AS-BUILT

VESSEL		FRV40 CLASS 63m FISHERIES RESEARCH VESSEL	
TITLE		CENTERBOARD BOTTOM VOID SCANTLINGS	
JOB NO.	M282	ITEM	160
DELIVERABLE	FH19	SHEET	001
REV	05	SHEET	1
FILE R/M282/FUNCTIONALDESIGN/INWORK/HULLDWGS		SHEET	1
		OF	2

DWG NO. M282-160-FH19 SH 1

DETAIL 11-C Δ^5 Δ^3
COVER PLATE (NT) DETAILS
1/8" THK GASKET BTW COVER PL AND BOLT RING

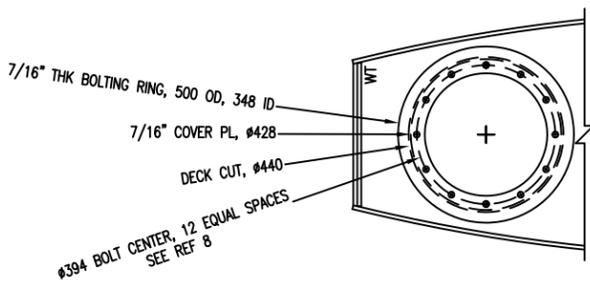
REVISIONS					REVISIONS				
REV	ZONE	DESCRIPTION	DATE	APPROVED	REV	ZONE	DESCRIPTION	DATE	APPROVED
4		1. SH 1: THIS REVISION REFLECTS AS-BUILT CONDITIONS FOR HULL 1953. 2. SH 2, ELEVATION 14-A & PLAN 10-A; RELOCATED SPARE TRANSDUCER AND SCIENTIFIC SONAR, ITEM #5C TO MATCH AS-BUILT CONDITIONS. 3. SH 2, DETAIL 11-C & SECTION 12-A; REVISED TO SUIT NEW LOCATIONS OF SPARE TRANSDUCER AND SCIENTIFIC SONAR, ITEM #5C. ITEMS 1 THRU 3 PER ENGINEERING DEVELOPMENT	7/2/07 MDP	7/3/07 FH	1		1. EXTENDED HULL APPLICABILITY TO INCLUDE HULL 1956. ITEM 1 PER ENGINEERING DEVELOPMENT.	5/1/05 AGE	5/1/05 FH
5		1. SH 2, PLAN 10-A; ADDED M284 APPLICABILITY CALLOUT TO SPARE TRANSDUCER PORT. 2. SH 2, DETAIL 12-C; ADDED DETAILS OF 70 KHZ TRANSDUCER MOUNTING/CLAMPING RINGS. ITEMS 1 & 2 PER ECP 112 THIS REVISION APPLICABLE TO M283/M284 ONLY	3/24/08 JWP		2		1. SH 2, PLAN 10-A: REVISED LAYOUT OF TRANSDUCERS TO SUIT ADDITION OF ANOTHER SCIENTIFIC SONAR TRANSDUCER BY RELOCATING THE SPARE TRANSDUCER OPENING FORWARD AND RELOCATING THE EXISTING SCIENTIFIC SONAR TRANSDUCER AFT; DELETED ACOUSTIC DOPPLER CURRENT PROFILER (ADCP) TRANSDUCER AND ITS WATERTIGHT COMPARTMENT; AND REDUCED THE SIZE OF THE SPARE TRANSDUCER OPENING TO 310. 2. SH 2, SECTION 12-A: ADDED DETAILS FOR THE NEW TRANSDUCER INSTALLATION. 3. SH 2, ELEVATION 14-A: REVISED LAYOUT OF TRANSDUCERS TO SUIT ADDITION OF ANOTHER SCIENTIFIC SONAR TRANSDUCER BY RELOCATING THE SPARE TRANSDUCER OPENING FORWARD AND RELOCATING THE EXISTING SCIENTIFIC SONAR TRANSDUCER AFT; DELETED ACOUSTIC DOPPLER CURRENT PROFILER (ADCP) TRANSDUCER AND ITS WATERTIGHT COMPARTMENT; AND REDUCED THE SIZE OF THE SPARE TRANSDUCER OPENING TO 310. 4. SH 2, SECTION 10-C: ADDED NEW DETAILS TO MODIFY FORMER WT BOUNDARY OF ADCP TRANSDUCER COMPARTMENT. 5. SH 2, DETAIL 11-C: ADDED DETAILS FOR COVER PLATE FOR THE SMALLER SPARE TRANSDUCER OPENING. 6. SH 2, PLAN 10-D: DELETED COVER PLATE OVER FORMER ADCP COMPARTMENT; AND ENLARGED OPENING IN TOP PLATE TO 530. ITEMS 1 THRU 6 PER ECP 0065	6/16/05 AGE	6/28/05 FH
